**STAFF RECOMMENDATION**  
*Approval, with Conditions*

**CASE FILE NO.:** Z0299-19-D

**PROPOSAL:** Design review of multi-family housing project: 6-story, 100-unit building. Site is adjacent to Fuller Road MAX Station. Proposal includes the building, parking and circulation, landscaping, new site access and right-of-way improvements.

# Building Elevations

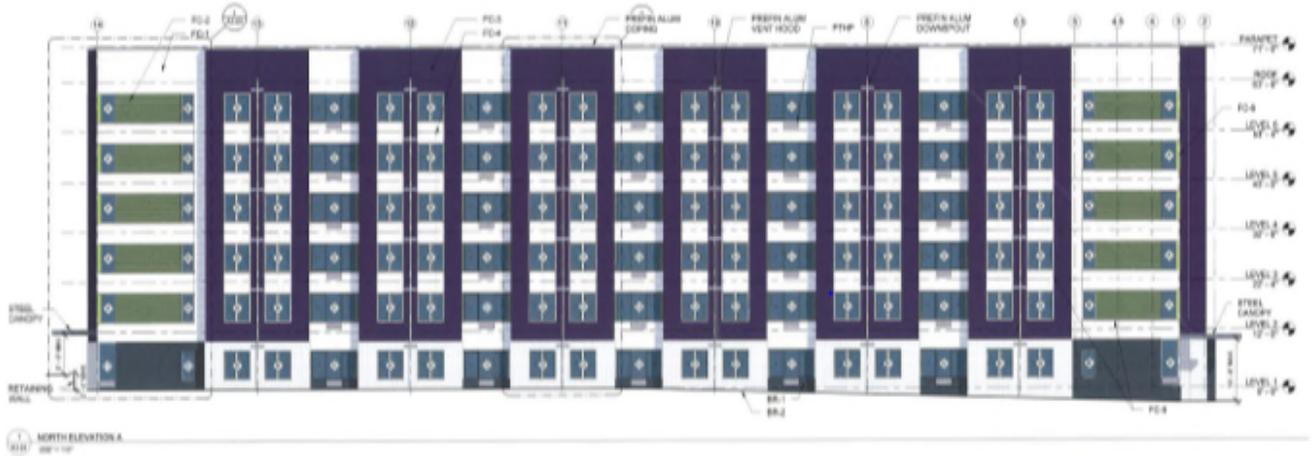
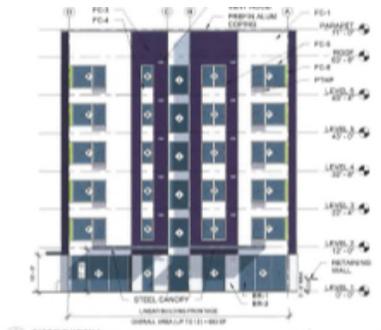
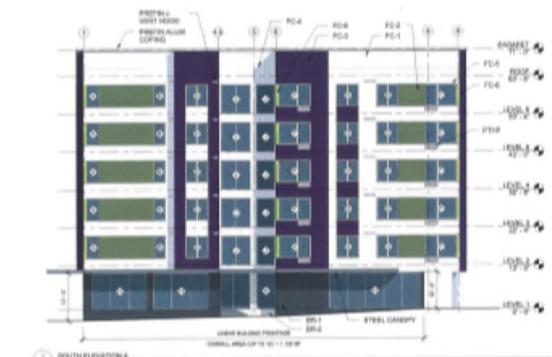
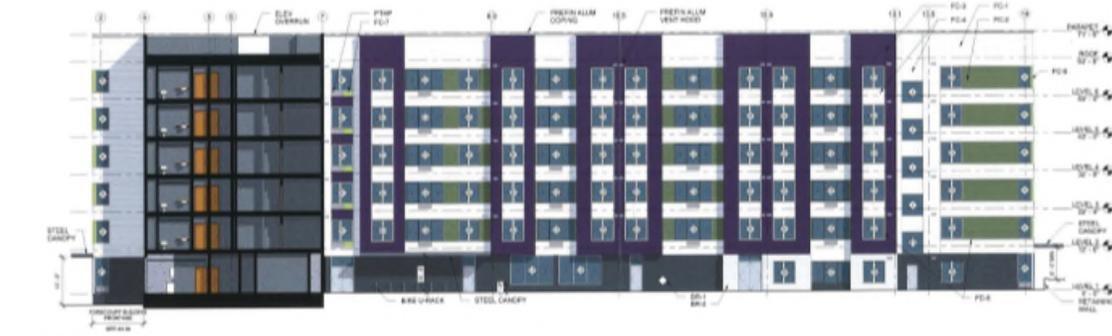
The proposed building has a roof without visible roof surfaces. As designed, there is a narrow band of aluminum coping along the parapet line. This is insufficient to provide the ‘cornice or architectural treatment’ required ‘to provide visual interest’, per 1005.04(D)(2).

The façade plane along residential units articulates approximately 30 inches in an attempt to create bays. However, the level of transparency in these building elements are insufficient for them to be considered on par with a ‘bay’ as might be expected of a bay window. There are no balconies proposed. Thus, the facades as designed do not comply with the requirement of 1005.04(F) for “buildings that are two or more stories in height shall have a minimum of one balcony or bay per four dwelling units”.

- B. **Prior to issuance of building permits**, the applicant shall submit revised façade drawings which include a cornice or architectural treatment designed to provide visual interest to the building, per the standards of ZDO 1005.04(D)(2).

- C. **Prior to issuance of building permits**, the applicant shall submit revised building elevation drawings demonstrating the provision of a minimum of one balcony or bay per four dwelling units, per the standards of ZDO 1005.04(F).
